File Note

Proposed Gull Station Development, Amohia Street/Kapiti Road - Peer Review

Figure 1 - Google Earth image from April 2016

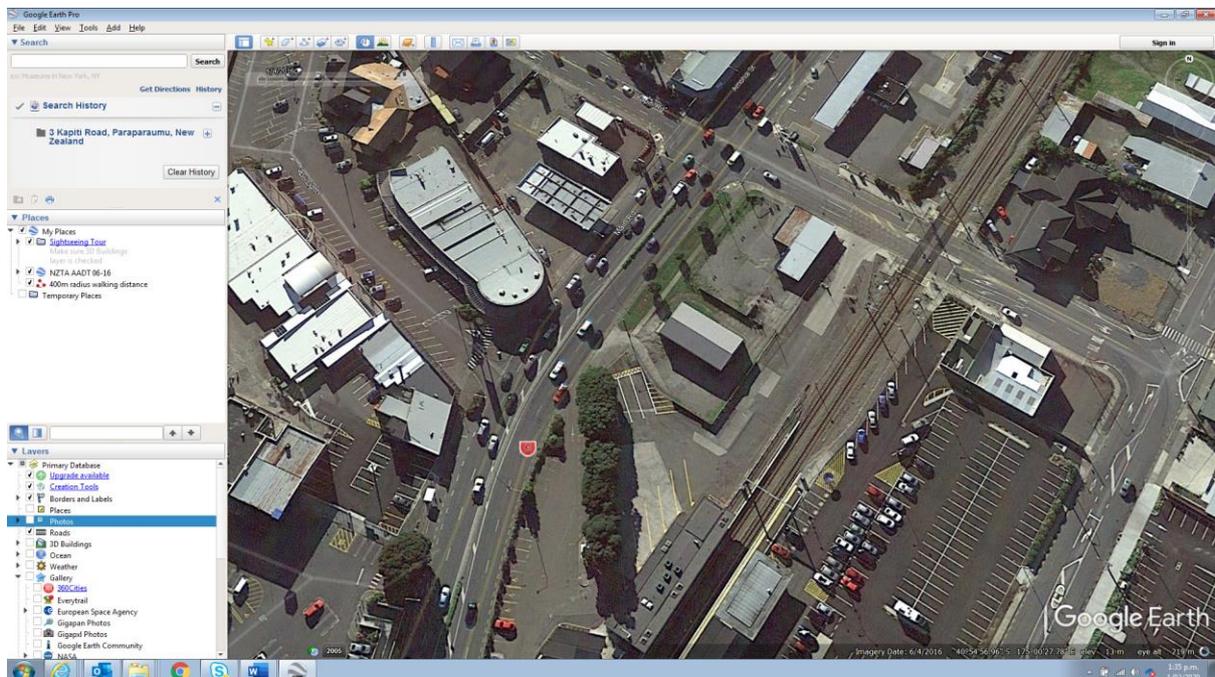
Current access to the site is via two access points from Amohia Street and Kapiti Road (east). While not discussed by Harrison Transportation, the previous use of the site appears, from historic images and maps, to have been used more recently to store buses over night and while there was a gate to access the site from Amohia Street, in the majority of the images they are closed and there are bus bays marked out against the gates suggesting this access may not have been used.

←→ Pedestrian Desire Lines

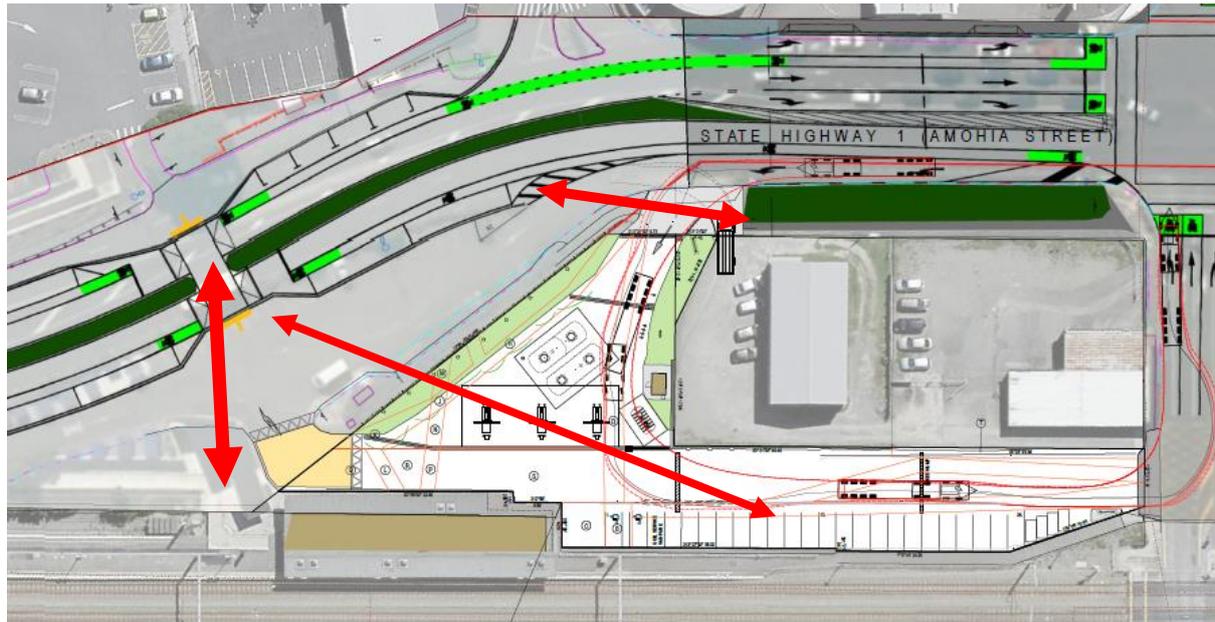
The original design, in the October 2018 report had a two way (left-in left-out) access at Amohia Street and a two-way (all movements) access at Kapiti Road. The latest design appears to have removed the left-out, at the same location, onto Amohia Street and the exit is now through the existing car parking area to the south of the site. However, no assessment has been presented on the impact of additional traffic using the car park access or on the car parking area itself.

While it is unclear when the improvements will be made on Amohia Street, from the latest drawings provided, there is now an at grade crossing, east to west across Amohia Street, and it has been single laned. From these changes, the exit from the service station into the car park now appears to be exactly at what would be the desire line for pedestrians exiting the railway station and using the at grade crossing.

With the at grade crossing, pedestrians currently using Kapiti Road, and the signals to cross Amohia Street, may cut through the railway station, or even the service station to cross, plus those that use the leased car parking spaces. Some clear, untracked over delineation for pedestrians would be recommended.

It is also unclear what pedestrian facilities are provided along Amohia Road. This may be more of an issue to be addressed by Council/NZTA but there appears to be a footpath along the frontage from the Kapiti Road lights south but these end at the driveway to JayCar/service station despite there appearing to be bus stops marked south of the driveway. I have general concerns about pedestrians, and also cyclists, navigating what will be a very wide access that includes the access to JayCar, the service station and the car parking area. Previous designs considered some type of pedestrian refuge area separating the ingress and egress for the service station but this is not incorporated into the new design.

Cyclists are also very exposed to conflict with the deceleration lane allowing for access for all three landuses also and the green cycle markings should at the very least be extended across the main access point to raise awareness to drivers of their presence. This should also include the exit point but there are no drawings of this point in the report.

Further, some traffic calming is recommended for the exit onto Kapiti Road to raise awareness of pedestrians crossing the footpath.
